**County Board Agenda Item
Meeting of April 25, 2009**

SUBJECT: U-3079-04-1 Use Permit Amendment to modify the required first floor clear height requirement from 15 feet to approximately 12.5 feet under Section 20. "CP-FBC" – Columbia Pike Form Based Code Districts, Subsection E.3. of the Arlington County Zoning Ordinance, in order to accommodate the inclusion of an existing historic facade. Property is approximately 68,654 SF, located at 1028 Walter Reed Drive and is identified as RPC: #32-006-028.

P. Brennan's Public House

Proposed Exterior View

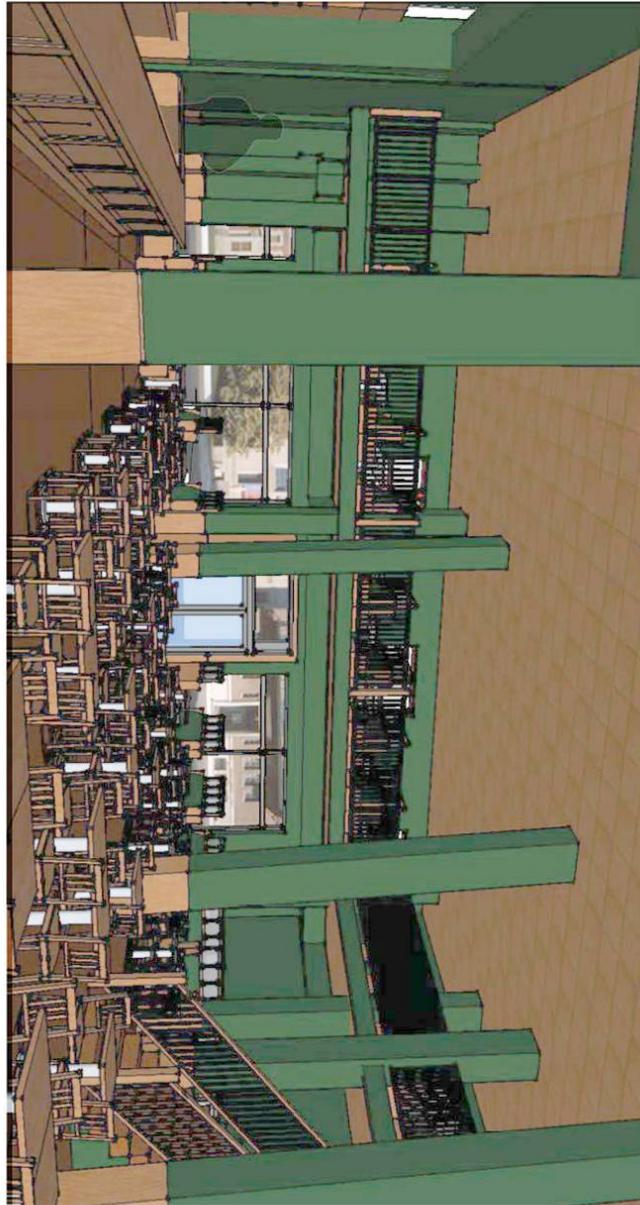
SUMMARY: The applicant is requesting a modification of the first floor clear height requirement under the Building Envelope Standards for Main Street sites, which is allowable under the Columbia Pike FBC, in order to accommodate a mezzanine in a restaurant (P. Brennan's) proposed in the space behind the historic Arlington Hardware facade incorporated into the Halstead project. With this modification, the mezzanine would be 12.5 feet from the first floor rather than the prescribed 15 feet, in order to remain compatible with the historic facade's second story windows and original second story floor location. The proposed mezzanine location would provide active uses behind the second story windows that can be seen from the adjacent street and sidewalk along Columbia Pike (see Attachment A and B).

Proposed Section [12'-6" clear height]

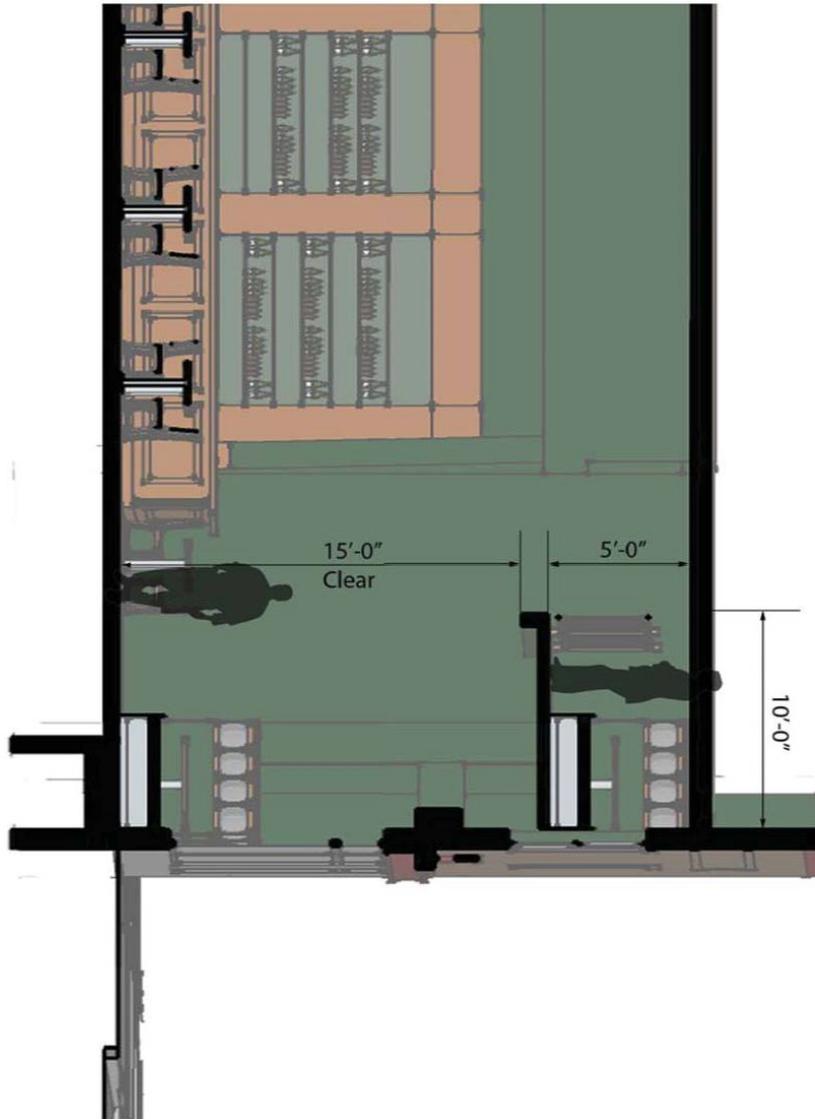
The use permit amendment is seeking to modify only one of these criteria as the remaining 4 will be satisfied by the proposed design (see Attachment C).

measured for at least one-third of the floor area contiguous with the RBL frontage. Reducing this height to 12.5 feet would allow the slab to be placed below the height of the windows, where it would accurately reflect the plans of the building as originally constructed. The applicant has worked with staff and the HALRB to develop an overall design for the P. Brennan's restaurant that is in keeping with the overall purpose and intent of the Form Based Code and the architectural style for the area, which includes several historically significant buildings. Staff concludes that the reduced clear height adjacent to the RBL along Columbia Pike to accommodate a mezzanine space is appropriate to accommodate the design of the existing, preserved façade and, with this design, the overall project will be improved.

Approve the amendment to modify the required first floor clear height requirement from 15 feet to 12.5 feet.

Proposed First Floor Plan

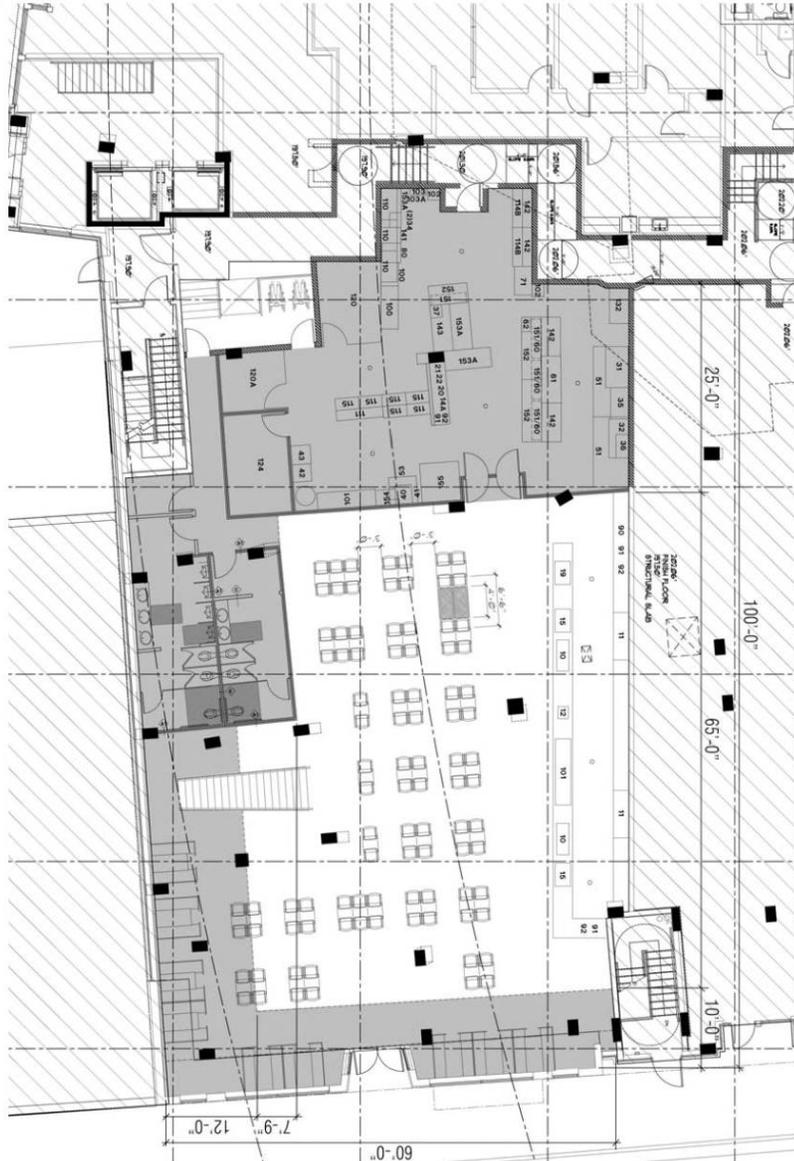
DISCUSSION: The applicant is proposing to locate a restaurant behind the Arlington Hardware historic façade in the Halsted Project. The applicant is requesting relief from a FBC clear height requirement for the first floor space involving a mezzanine. No other modifications are requested or needed. With the proposed design, the slab placement for the mezzanine is consistent with the original location of the second floor in the Hardware building, just underneath the existing windows of the historic façade. This would allow the mezzanine to serve the restaurant’s patrons and offer a space overlooking the street (see Attachment D). If the required 15-foot clearance were to be used, this would place the mezzanine slab within the second story windows (see Attachment E).
